**TOWN OF NEWBURGH
PLANNING BOARD
TECHNICAL REVIEW COMMENTS**

PROJECT: LANDS OF JAN KADNAR
PROJECT NO.: 20-09
PROJECT LOCATION: SECTION 6, BLOCK 1, LOT 10.5
REVIEW DATE: 11 DECEMBER 2020
MEETING DATE: 17 DECEMBER 2020
PROJECT REPRESENTATIVE: VINCENT J. DOCE ASSOCIATES

SUBDIVISION PLAN
 LANDS OF
 JAN KADNAR
 275 PRESSLER ROAD, TOWN OF NEWBURGH
 ORANGE COUNTY, NEW YORK
 DATE: JUNE 17, 2020 SCALE: 1 IN. = 100 FT.

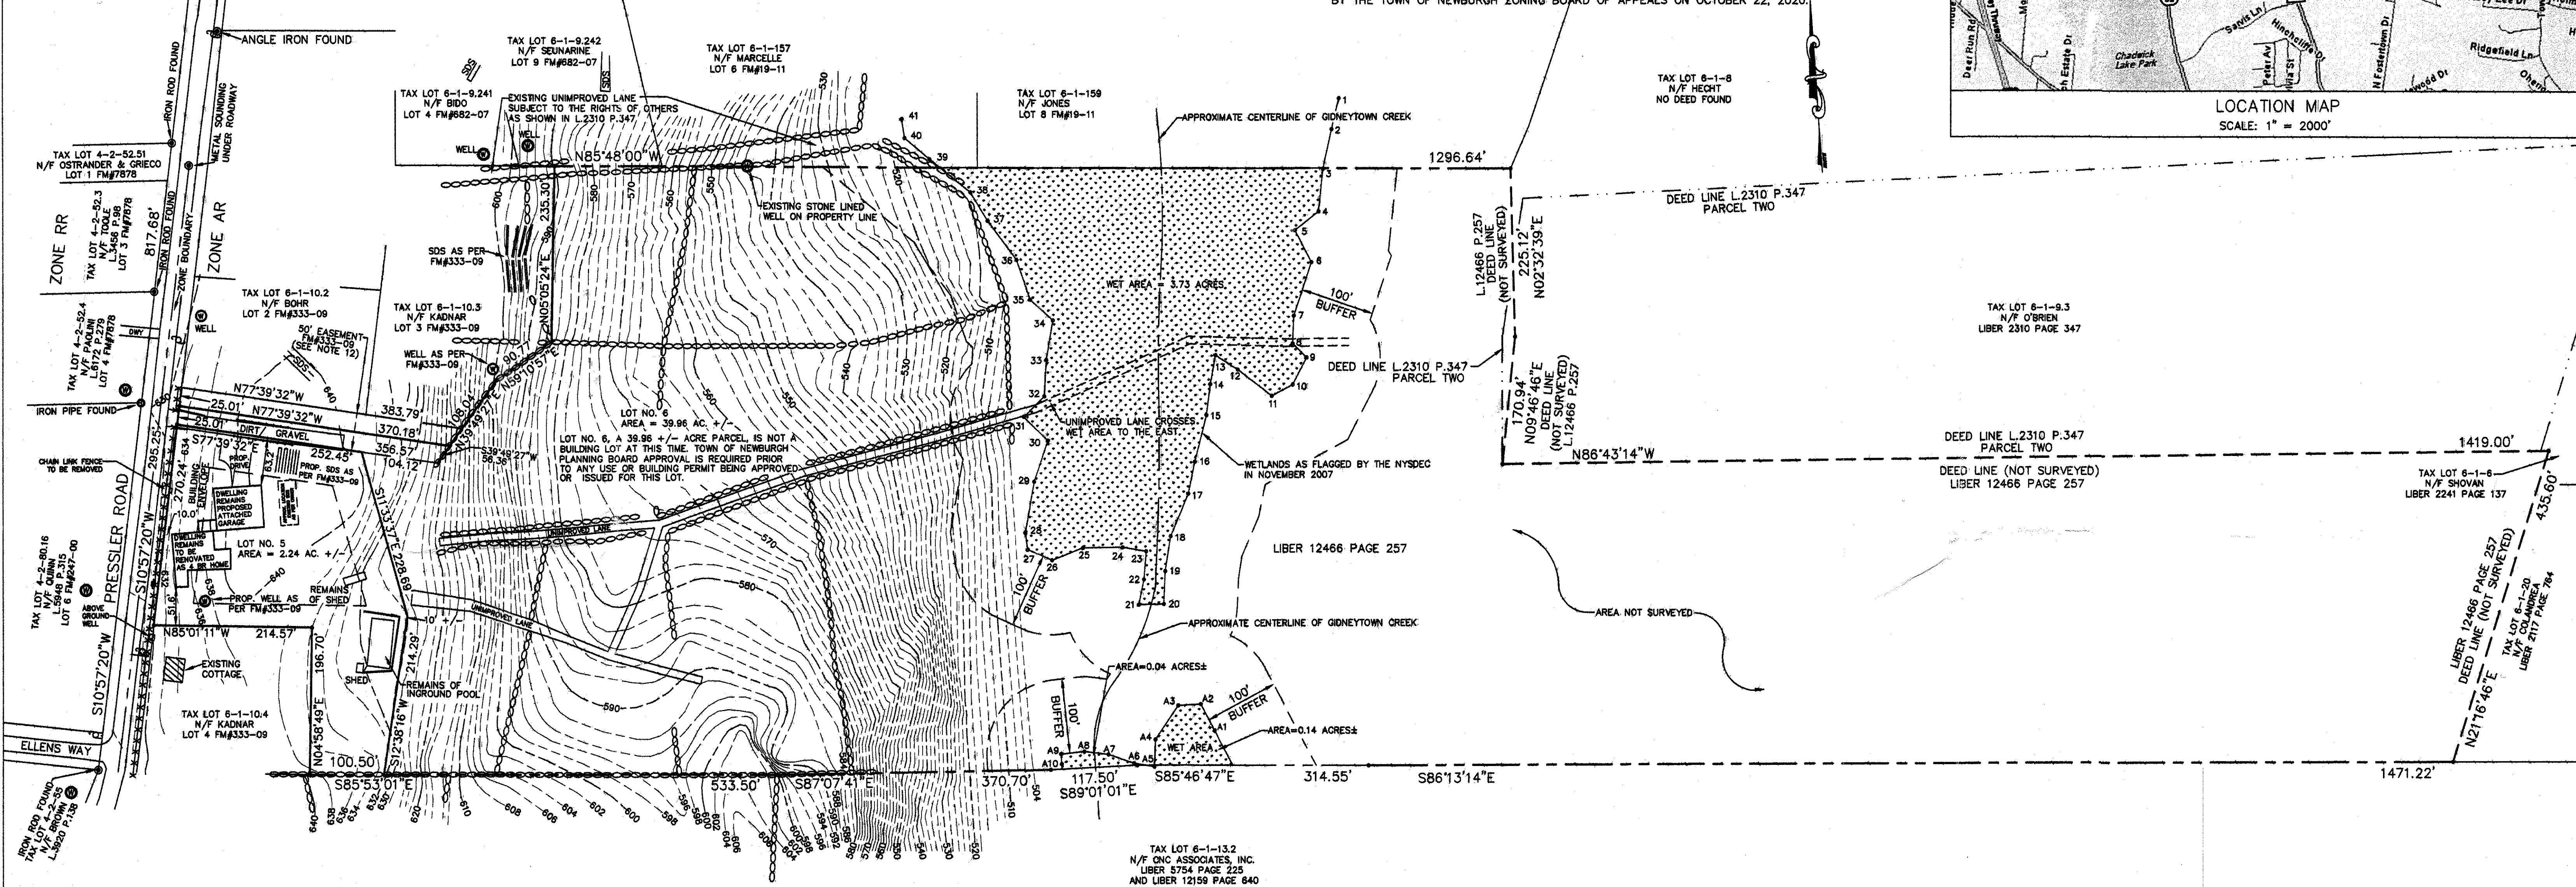
1. The project as designed will permit access to three lots from a common driveway. The large balance parcel contains a note identifying “not a building lot at this time”. Any approvals of the parent parcel will require review and approval by the Planning Board at which time the access will be addressed.
2. The project has received required variances from the ZBA.
